Focused Review of Specific Remediation Issues

An Addendum to the Remediation System Evaluation
for the
Homestake Mining Company (Grants) Superfund Site, New Mexico

Final Report
December 23, 2010

Prepared by US Army Corps of Engineers
Environmental and Munitions Center of Expertise
For US Environmental Protection Agency, Region 6

Figure 1b. Well Locations

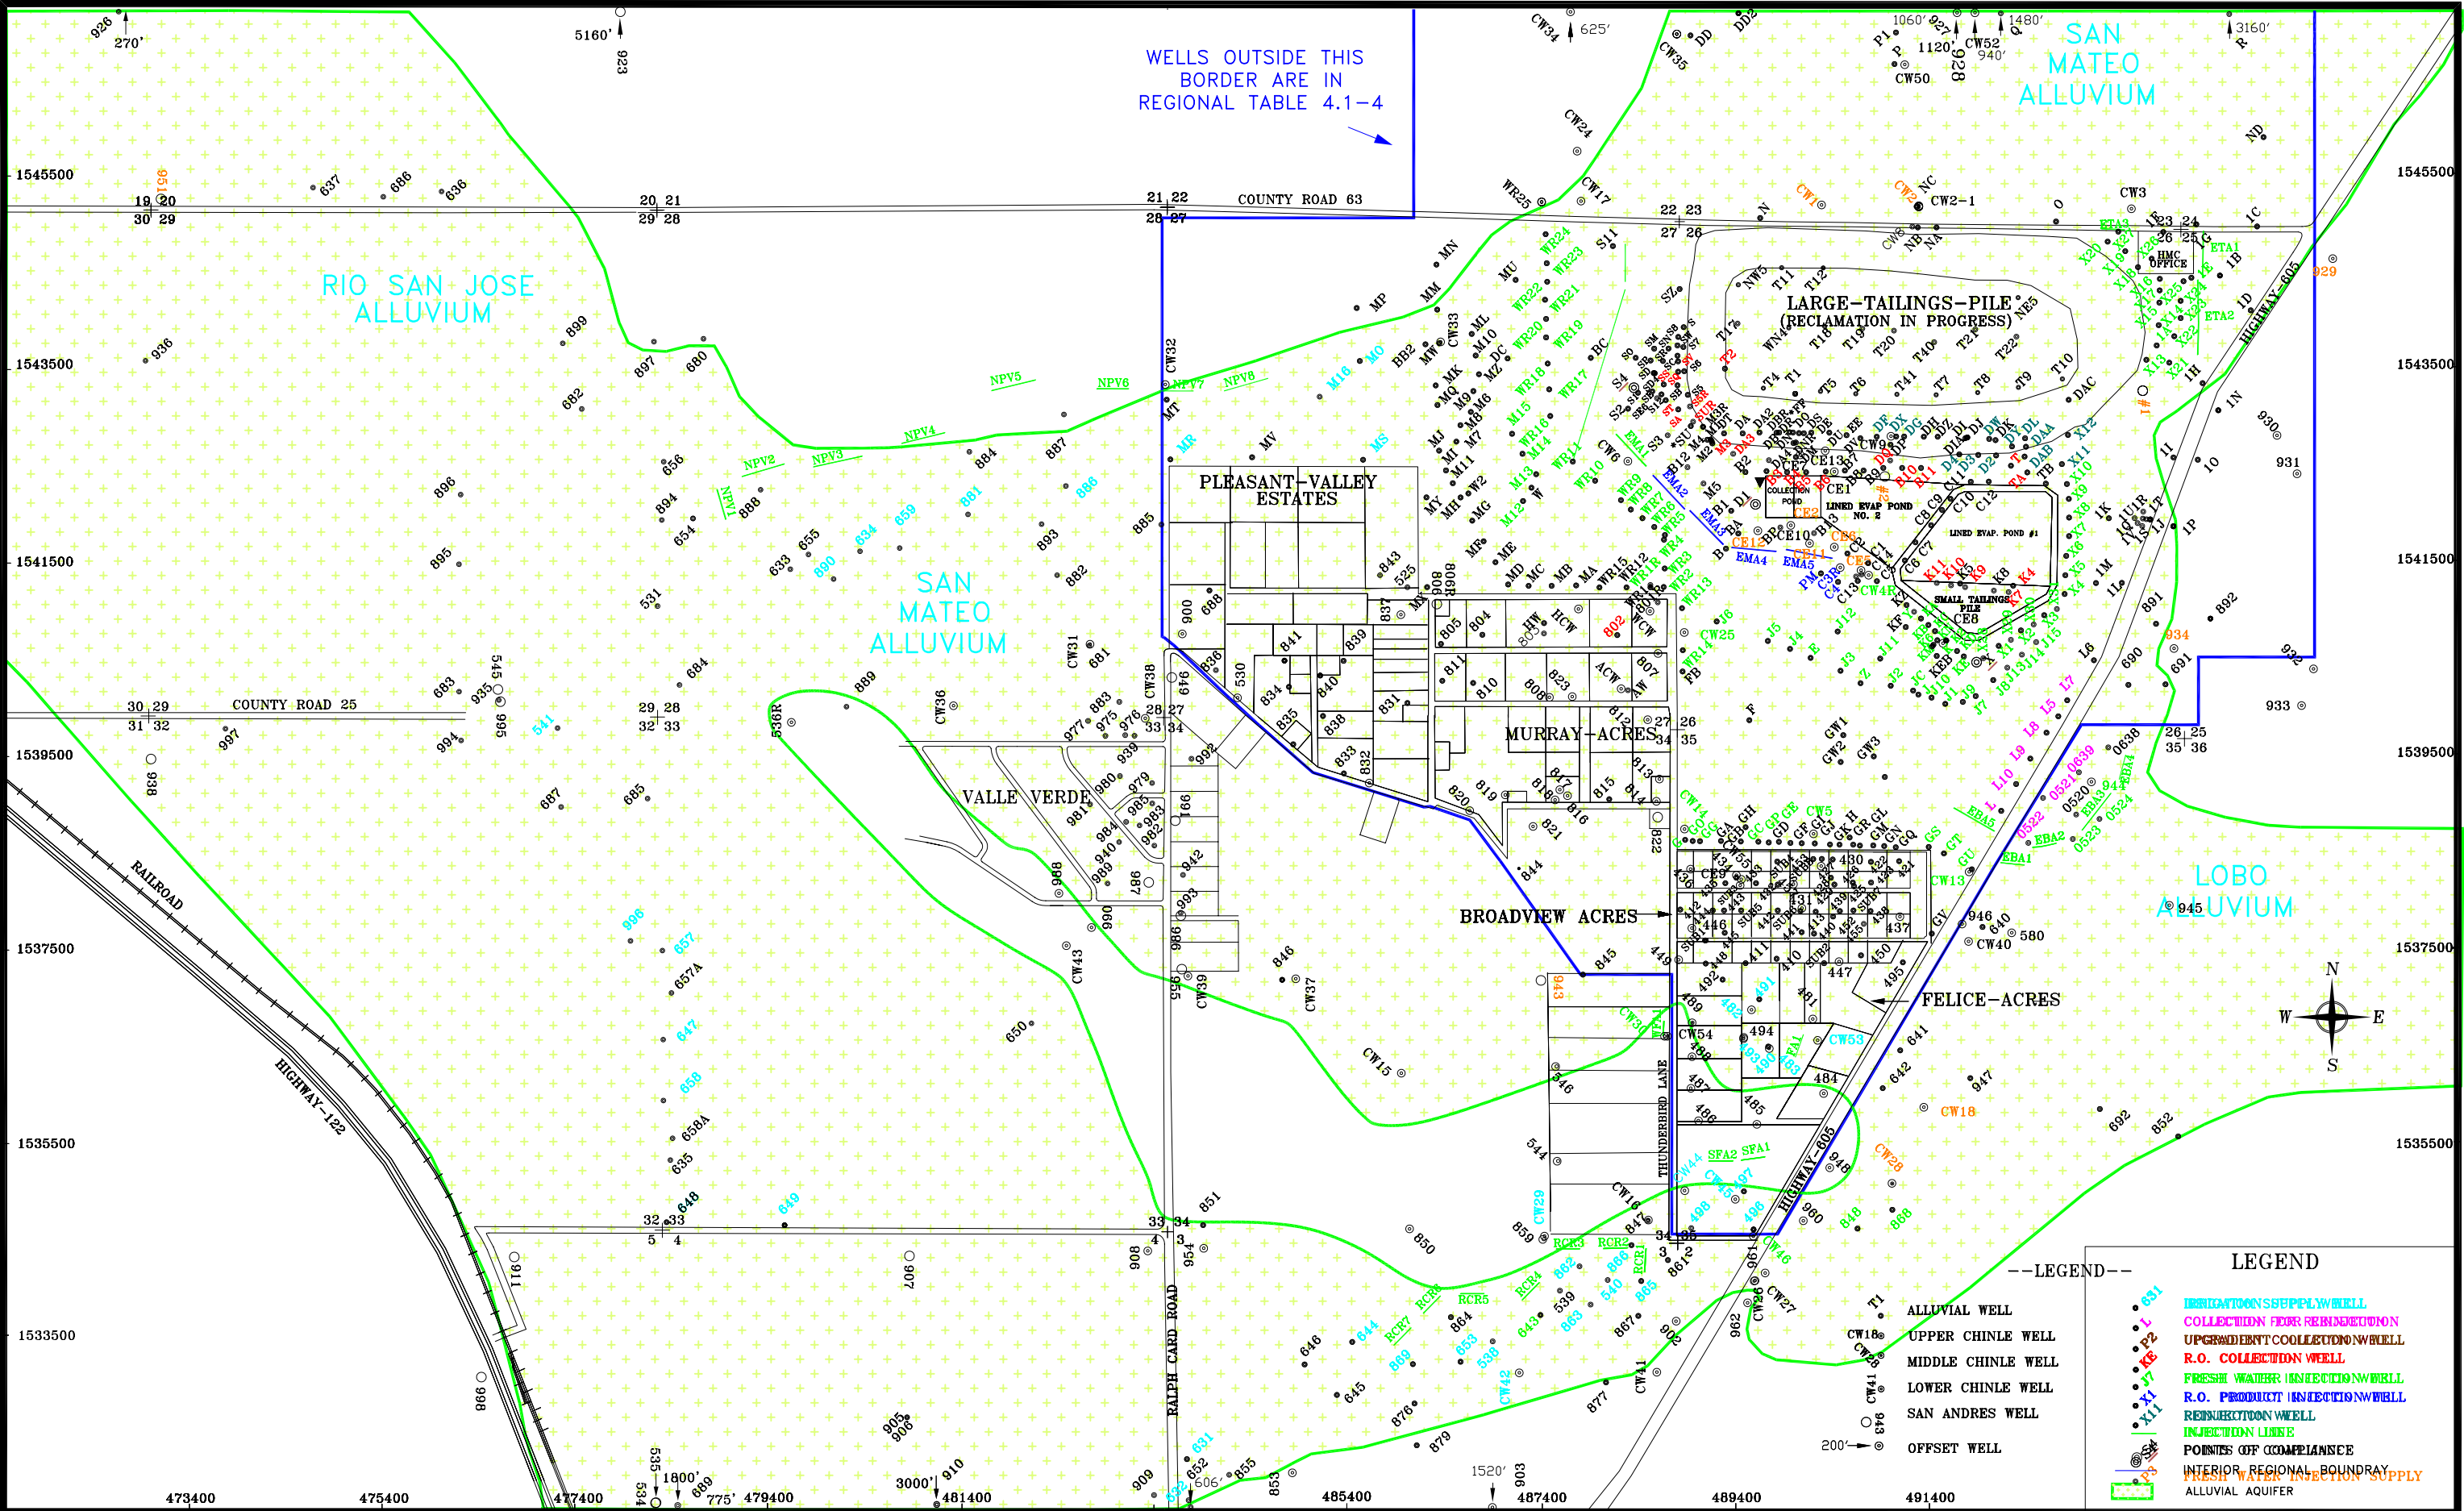
89	EPA	Figure 1	9	Add a figure that clearly indicates monitoring well locations. I can not identify monitoring wells referenced in the report on this figure.	Concur	We will attach a separate file in 11x17" format such that it can be more easily read.
90	EPA	Figures	11	Please check the labels on the x and y axes – the dates and other units are not correctly located or easy to read. Please reformat figures to allow for accurate reading of the x and y values.	Concur	Text will be revised.
91	EPA		17	last paragraph, 3 rd sentence. Change ‘has’ to ‘have’ and change figure to “Figure 15 in the same sentence.	Concur	Text will be revised.
92	EPA		18	paragraph in the middle of the page regarding additional testing of oxidation-reduction potential. Please elaborate on the types of add'l testing that would be necessary and how the data should be interpreted.	Concur	We will elaborate to indicate that downhole ORP and pH measurements would be useful to assessing the likely state of the U in the pile and the impacts from the flushing program on the stability of the U.

Figure 1 at p. 9 is not sufficiently detailed to identify the location of the wells of concern discussed in this section, as well as other sections of the Report. Figure 1 does not identify the locations of wells DD or S11 or the flow paths of concern on the west side of the tailings pile.

Neither Figure 1 nor other figures identify the location of fault zones in the project area, the extent of the alluvial aquifer, or other geologic features that might influence ground water flow paths on the west side of the large tailings pile. The “scanned” well location maps posted by the RSE contractor team on the HMC RSE Quickr website provide additional detail but are not clearly integrated into the DRSE Report.

The DRSE Report should be supplemented to address the location of well DD and its associated flow path within the footprint of proposed evaporation pond 3 (neither well DD or EP3 are identified on Figure 1) and the challenges to investigation and remediation of the ground water with rising uranium content in the well DD/well S11 area north and west of the large tailings pile.

Figure 2. Conceptual Site Model (CSM) Summary

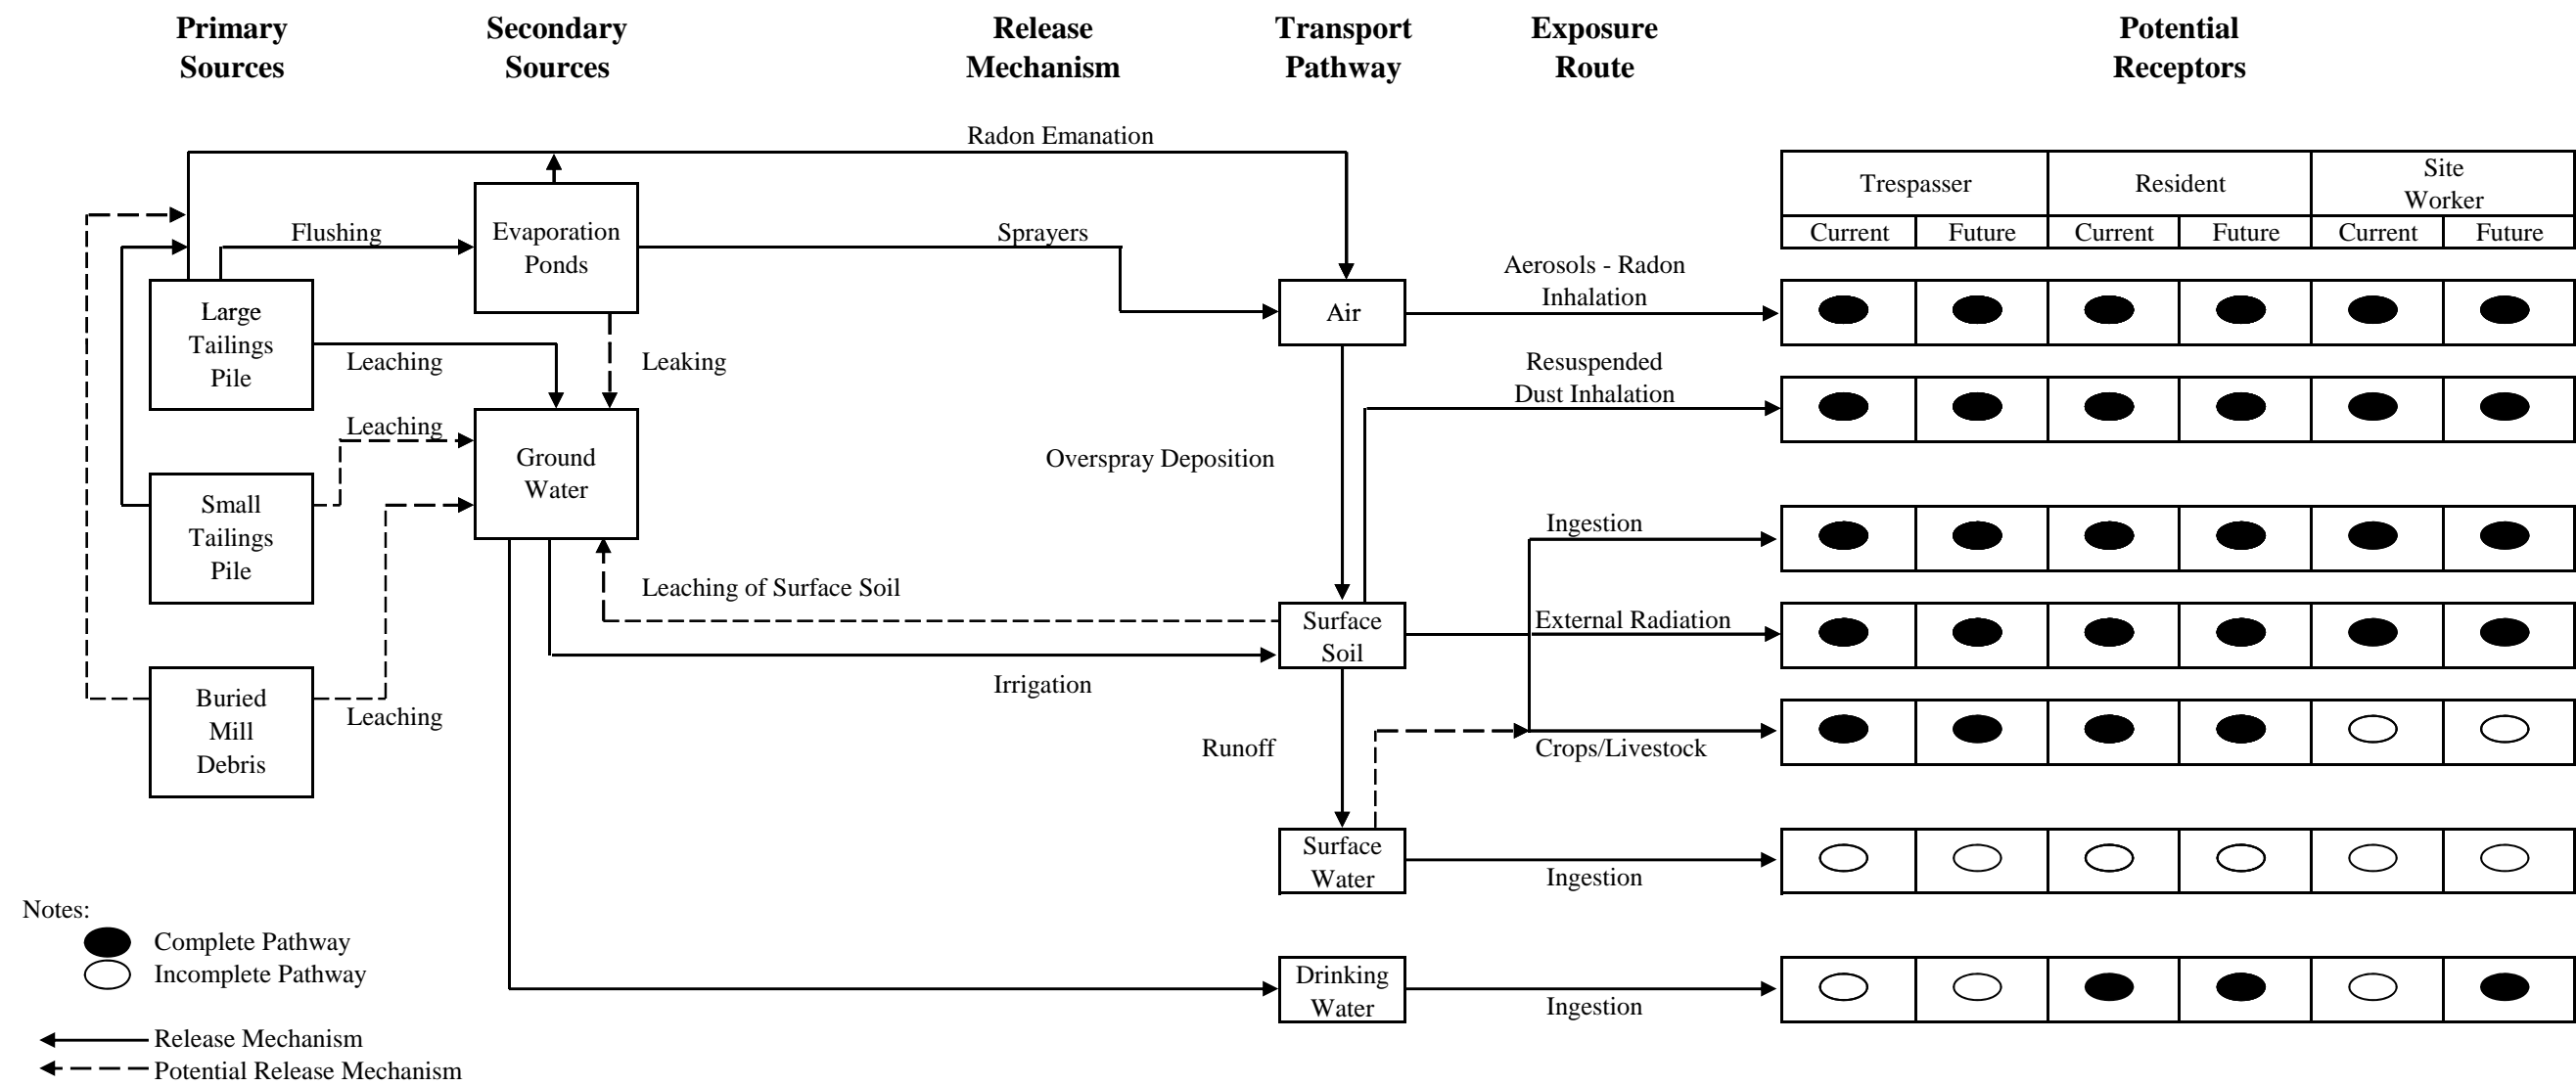
27	HMC	2.3	7	<p>The text incorrectly refers to Figure 1 as the conceptual site model. The conceptual site is shown on Figure 2. HMC believes that the conceptual site model is flawed. As discussed in our response for Recommendation No. 4, HMC does not believe that the former mill area is a “Primary Source,” as depicted on the conceptual site model. Additionally, several of the exposure pathways that are indicated as complete are actually not complete. An example of this is the incomplete groundwater drinking pathway for a trespasser, resident, or worker, currently and in the future. We suggest that the ACOE reexamine this conceptual site model before issuing the final RSE report.</p>	Non-Concur, in part	<p>The reference to the CSM Figure will be corrected. The CSM sources and pathways will be reevaluated based on this and other stakeholder comments and the information compiled by HMC in the annual Land Use Review/Survey. The descriptions and figure will be clarified to better indicate known sources, receptors and transfer pathways and potential sources, receptors, and transfer pathways.</p>

Section 2.3 and Figure 2, Receptors; page 7. The text incorrectly refers to Figure 1 as the conceptual site model. The conceptual site is shown on Figure 2. HMC believes that the conceptual site model is flawed. As discussed in our response for Recommendation No. 4, HMC does not believe that the former mill area is a “Primary Source,” as depicted on the conceptual site model. Additionally, several of the exposure pathways that are indicated as complete are actually not complete. An example of this is the incomplete groundwater drinking pathway for a trespasser, resident, or worker, currently and in the future. We suggest that the ACOE re-examine this conceptual site model before issuing the final RSE report.

53	NMED	2.3	7	The last sentence should refer to figure 2 instead of figure 1.	Concur	The text will be corrected.
54	NMED	3.2	8	Please move x-axis label to the bottom of figures 3, 4, and 8.	Concur	The readability of the charts will be improved in several ways.

Figure 3. Well X Uranium Concentration Trends.

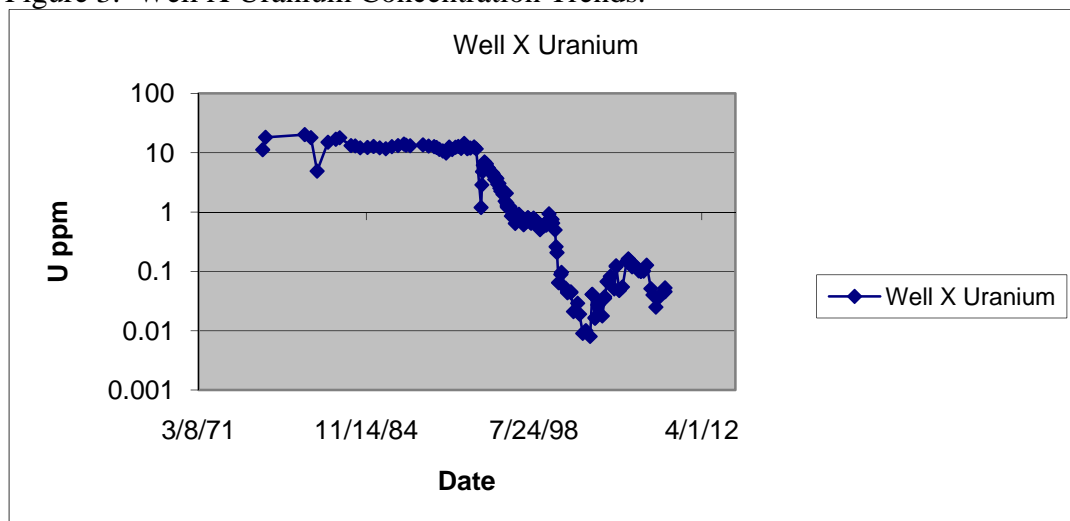
Figure 3 on p. 8 illustrates the downward uranium trend in well X.

Review of the uranium concentration trend for well X in Figure 3 shows that the uranium concentration in the well remained relatively steady for several decades before a steep drop in uranium concentrations was detected.

Figure 3 shows the drop in uranium concentration occurring after the construction of EP1 and the injection wells – including the "1993 J-line" of injection wells – along the south perimeter of EP1 and the small tailings pile. Figure 1 shows well X to be in such close proximity to injection wells that the symbols for the two are touching on the figure.

Figure 13. Well DD Uranium Concentration Trends.

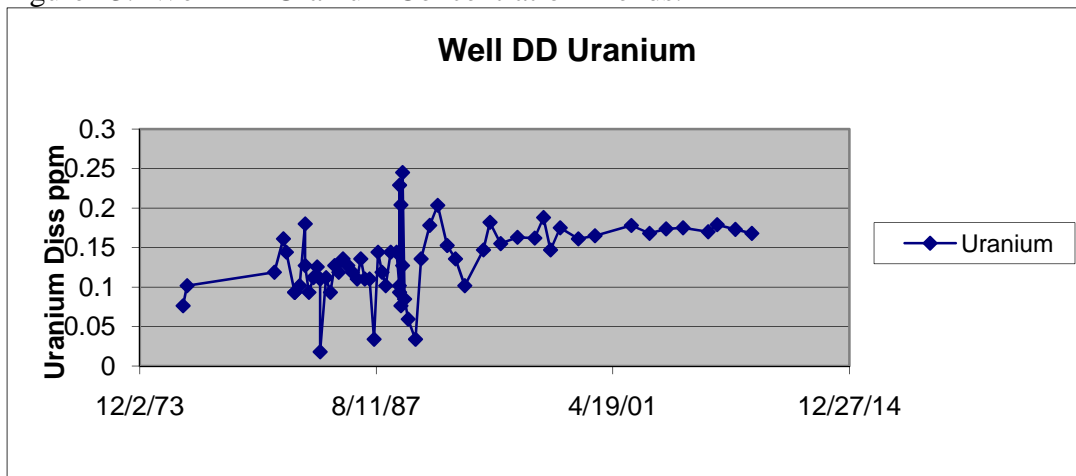
The DRSE Report shows a rising uranium trend in well DD in Figure 13 which results in a doubling of the uranium concentration in that well from the initial data point, which appears to be from the 1970s. The DRSE Report recommends the adoption of efforts to “further evaluate capture of contaminants west of the northwestern corner of the large tailings pile.”

Figure 14. Uranium Concentrations in Large Tailings Pile

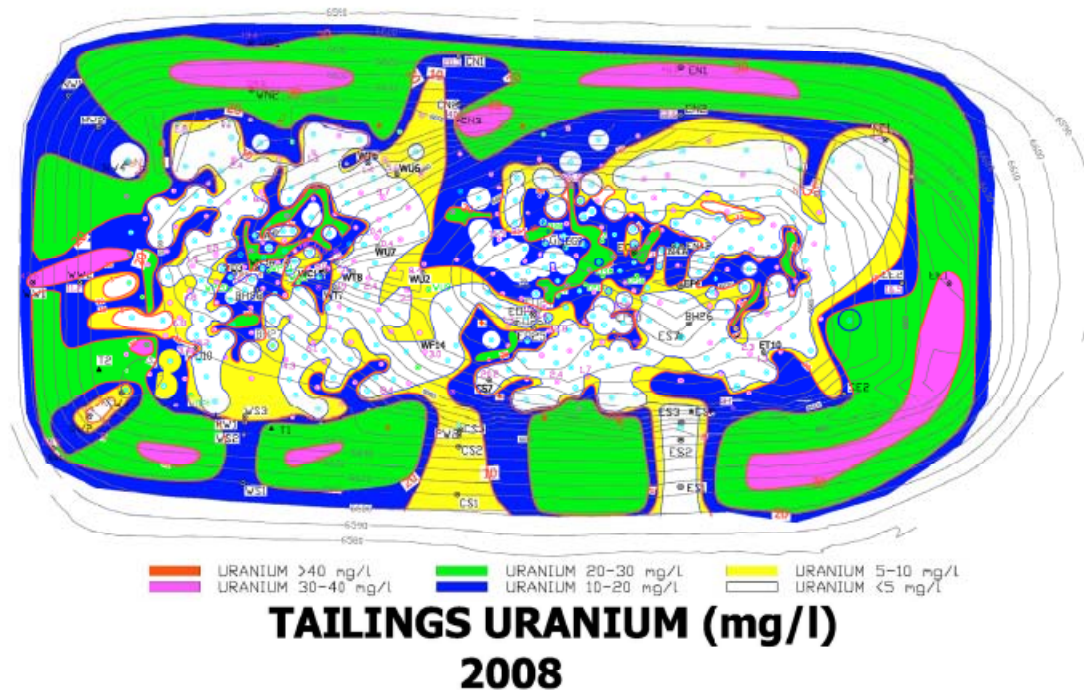
34	HMC	4 & Fig. 14	17	<p>The flushing of the large tailings pile is discussed and Figure 14 is used to show the 2008 uranium concentrations in the tailings. Although the ACOE uses this figure to show the variability of uranium in the pile and illustrate their belief that the flushing has not been effective, HMC believes that the flushing has been effective at removing uranium mass. This is demonstrated by comparing the 2000 and 2009 maps for uranium in the tailings pile, which shows that a significant amount of uranium has been removed. See also HMC's response to Recommendation No. 2 for additional evidence of the effectiveness of the flushing and extraction program. Below is the 2000 uranium concentration map for the tailings pile showing uranium concentrations exceeding 30 mg/L in much of the pile. Also below is a map of the 2009 uranium concentrations in the pile, which illustrates the significant reduction in concentrations resulting from the flushing and extraction program. For 2009, approximately 67.5 percent of the west side slime area has uranium concentrations less than 5.0 mg/L, and 45.5 percent of the same area has concentrations lower than 2.0 mg/L.</p>	Non-concur	<p>The flushing program has made some progress, as the report acknowledges. As discussed above and in the report, the concern is that the long screens of the monitoring points makes it likely that injected water has impacted the monitoring point, but that the ambient concentrations may be much different. The map was meant to illustrate the wide variations in concentrations at closely spaced points such that the flushing is clearly not uniform.</p>

Section 4.1 and Figure 14, Flushing of Large Tailings Pile; page 17. The flushing of the large tailings pile is discussed and Figure 14 is used to show the 2008 uranium concentrations in the tailings. Although the ACOE uses this figure to show the variability of uranium in the pile and illustrate their belief that the flushing has not been effective, HMC believes that the flushing has been effective at removing uranium mass. This is demonstrated by comparing the 2000 and 2009 maps for uranium in the tailings pile, which shows that a significant amount of uranium has been removed. See also HMC’s response to Recommendation No. 2 for additional evidence of the effectiveness of the flushing and extraction program. Below is the 2000 uranium concentration map for the tailings pile showing uranium concentrations exceeding 30 mg/L in much of the pile. Also below is a map of the 2009 uranium concentrations in the pile, which illustrates the significant reduction in concentrations resulting from the flushing and extraction program. For 2009, approximately 67.5 percent of the west side slime area has uranium concentrations less than 5.0 mg/L, and 45.5 percent of the same area has concentrations lower than 2.0 mg/L.
